CITY OF MENDOTA HEIGHTS

PLANNING COMMISSION REGULAR MEETING AGENDA

FINDINGS-OF-FACT FOR APPROVAL**MRCAA -Critical Area Permit
for
Planning Case No. 2026-01 (Homes by Tradition)**

SITE & GRADING PLAN

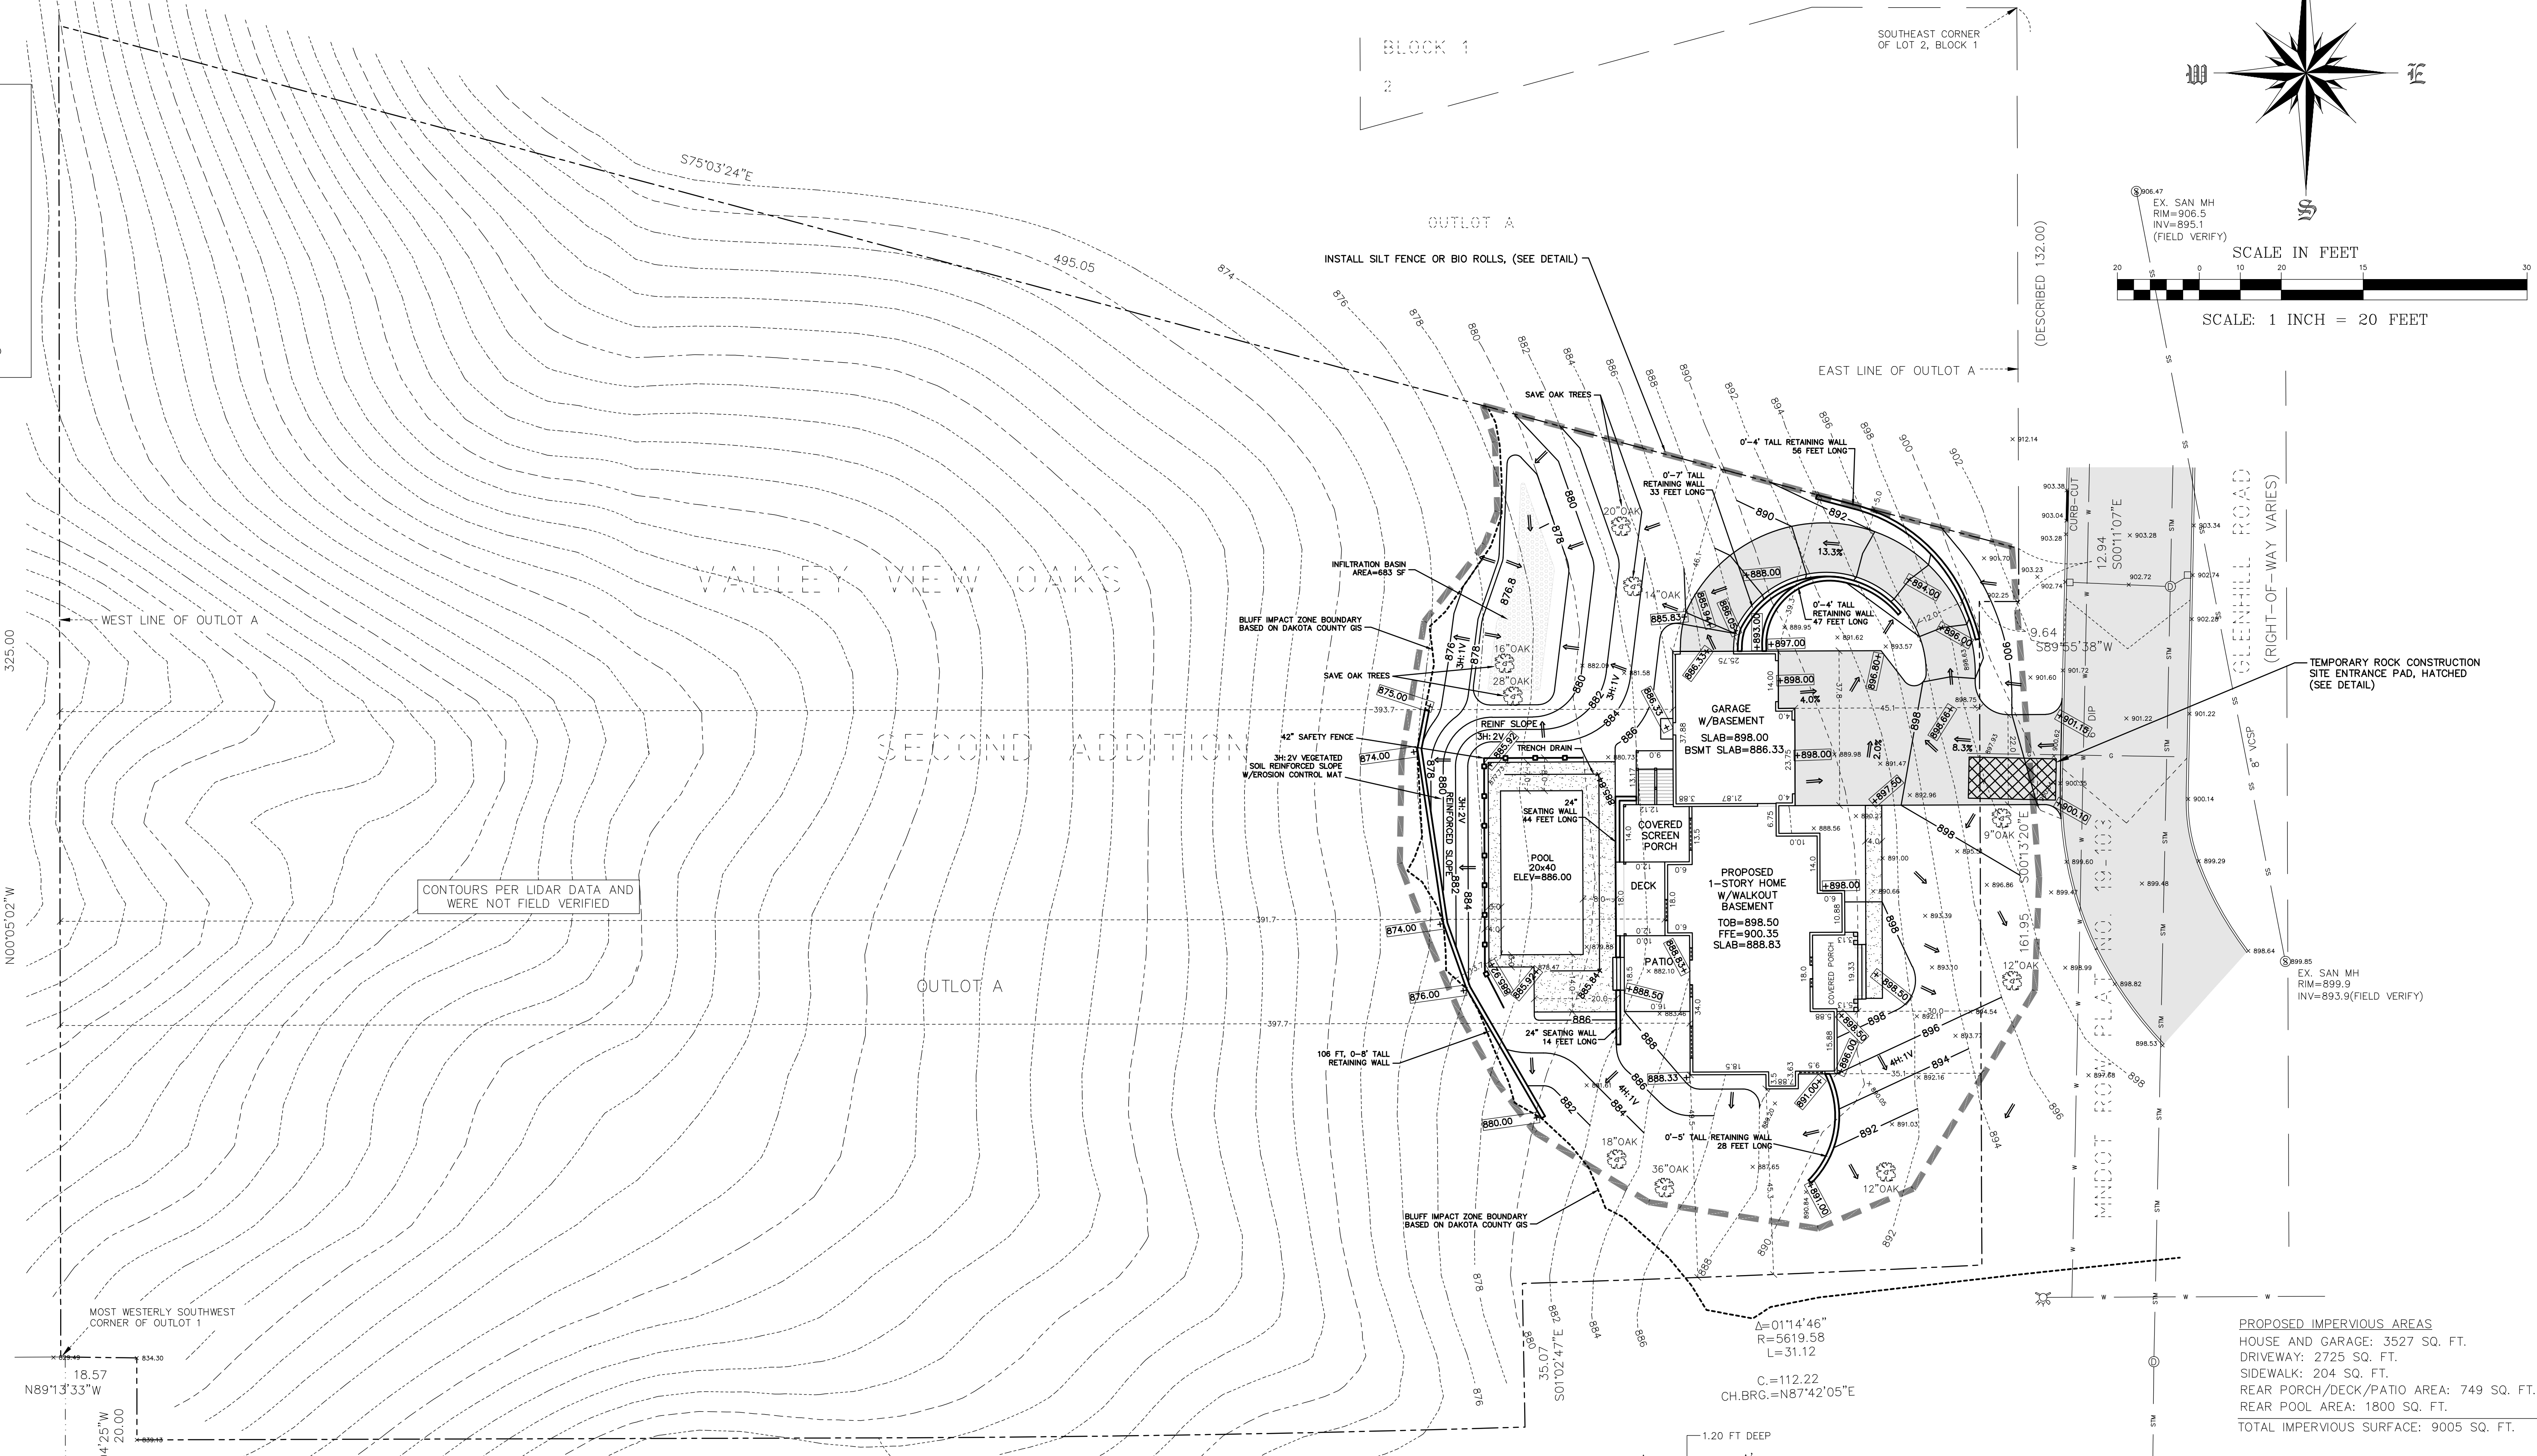
This improvement cannot be approved as part of the MRCCA Permit for this new home, and will either need to be relocated on the plan, removed from the site plan, or the applicant will need to apply for and receive a Variance for this setback reduction.

The applicant's provided site plan illustrates that there are no planned improvements or impacts within the bluff impact zone. However, many of the improvements and site impacts are placed just outside of the BIZ boundary. Section 10 of the City's MRCCA Ordinance regulates land alteration standards and stormwater management. The ordinance allows development on steep slopes outside of the BIZ if the applicant can demonstrate that the proposed development can be accomplished without increasing erosion or stormwater runoff and the geology is suited to the development.

1. A building permit, including a grading plan, must be approved by the City prior to the commencement of any site work.
2. The swimming pool and surrounding pool decking/patio area must be removed from the site plan, or relocated elsewhere on the site plan outside the bluffline setback prior to the City taking action on this application. No structures or facilities, including impervious surfaces, may be located within the bluffline setback.
